# Planning Commission Agenda Item

**SUBJECT: ZN-20-2024 CENTENNIAL LOSEE (Public Hearing).** Applicant: Greystone Nevada, LLC. Request: A Property Reclassification of 17.97 Acres from a PUD, Planned Unit Development District to a PUD, Planned Unit Development District, Consisting of 288 Multi-Family Dwelling Units. Location: Northwest Corner of Losee Road and Azure Avenue. (APNs 124-26-501-019 and 124-26-501-020) Ward 2. (For Possible Action)

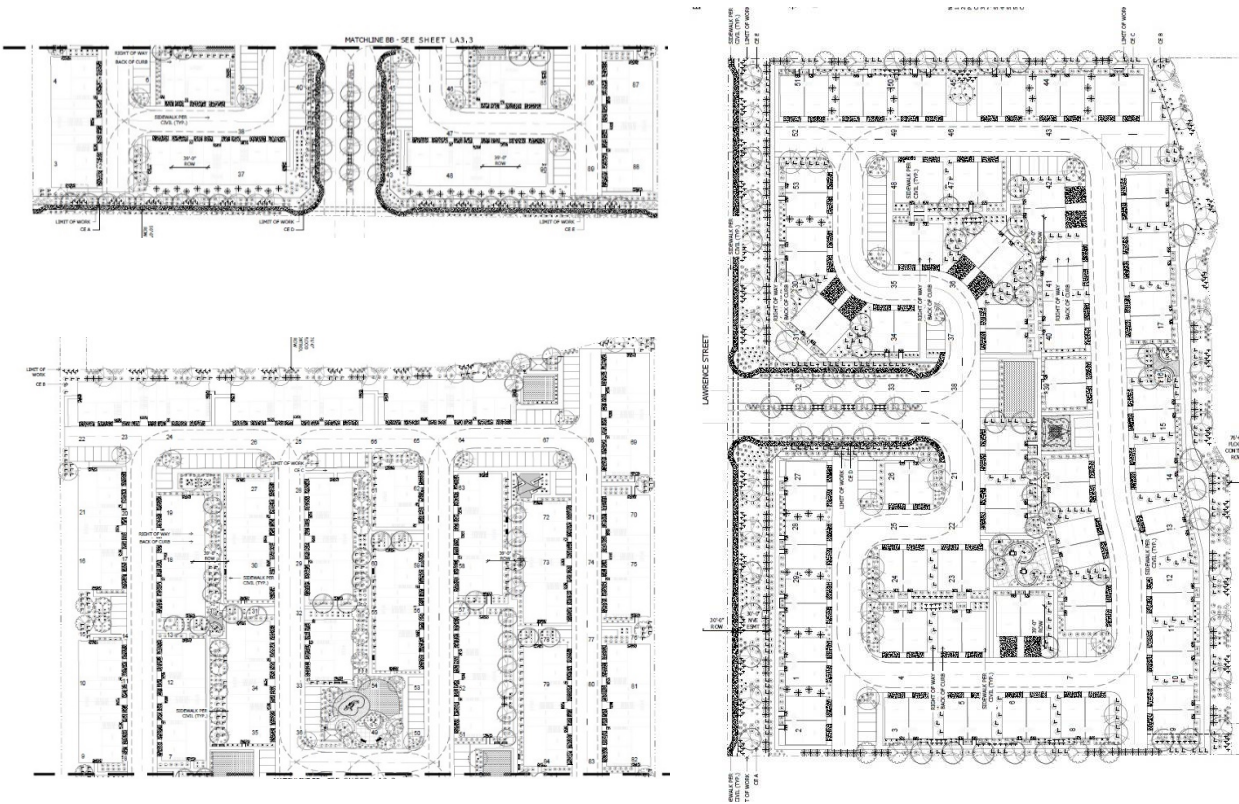
The proposed preliminary development plan indicates the west development's main access and the required secondary fire access from Lawrence Street and the east development will have primary access and secondary fire access from Losee Road.

The proposed landscaping plan indicates the perimeter landscaping of 35 feet along North Lawrence Street including a five (5) foot sidewalk. There is an existing City water line along Lawrence Street, which creates the need for the wider landscaping where the required perimeter landscaping along North Lawrence Street is fifteen (15) feet including a five (5) foot sidewalk. The required perimeter landscaping along Losee Road is twenty (20) feet including a five (5) foot sidewalk. The proposed landscape plan complies with this requirement. The perimeter landscaping appears to be in compliance with code requirements. The proposed landscape plan indicates a view fence is provided along the trail/wash area for both the west and east portions of the development.

The proposed west development area will contain duplexes 41 feet long and 46.83 feet wide with a five (5) foot rear driveway to access the two (2)-car garage. The driveways will be required to be a decorative brick to distinguish the difference between the drive aisle and the driveway and to enhance the alleyway with a decorative element. The drive aisles will be 34 feet wide with five (5) feet of sidewalk on each side. In addition, there is a walking path throughout this portion of the development. The sidewalk should be widened to seven (7) feet, which is consistent with similar PUD developments. This should enhance the comfort for residents when using the pathway.

3. All driveways within the west portion single-family duplex shall have brick driveways.
4. All pathways within both developments shall be 7 feet wide.
5. The following amenities shall be provided within the open space areas: turf area, age appropriate playground equipment with EPDM surfacing, shade sail, picnic table. Ramada, benches, game table, trash receptacles and dog waste stations.

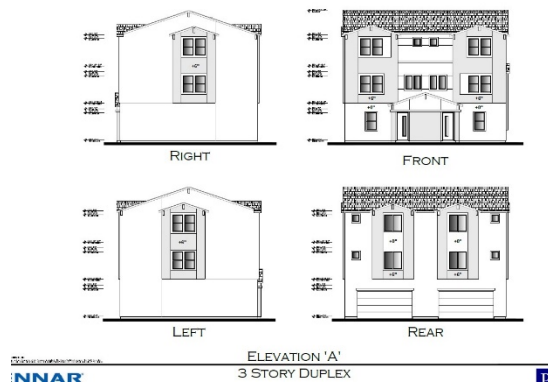
The west portion of the proposed PUD development is required to provide 57,600 The applicant has provided three (3) small park areas for a total of 4,511 square feet of useable open space within the development as well as sidewalk pathways. The sidewalks should be increased to seven (7) feet wide for residents comfort. Only private open space with a width of 20 feet or more can be counted towards this requirement. The proposed site is located near the Centennial-Lawrence Trailhead immediately to the north. This public park can be considered an amenity to the development. The code allows developments within five hundred (500) feet of an improved public park, plaza, or other

open space and connected by a continuous sidewalk meeting the Americans with Disabilities Act may be approved with reduced open space areas within the project. This project is adjacent to the park north of the development using Lawrence Street. The applicant should also provide pedestrian access to the existing trail from the eastern portion of the proposed PUD. The proposed park amenities for the west development have been identified as; turf area, tot lot with EPDM surfacing, shade sail, picnic table, ramada, benches, game table, trash receptacles and dog waste stations. The amenities should be confirmed with the Final Development Plan.
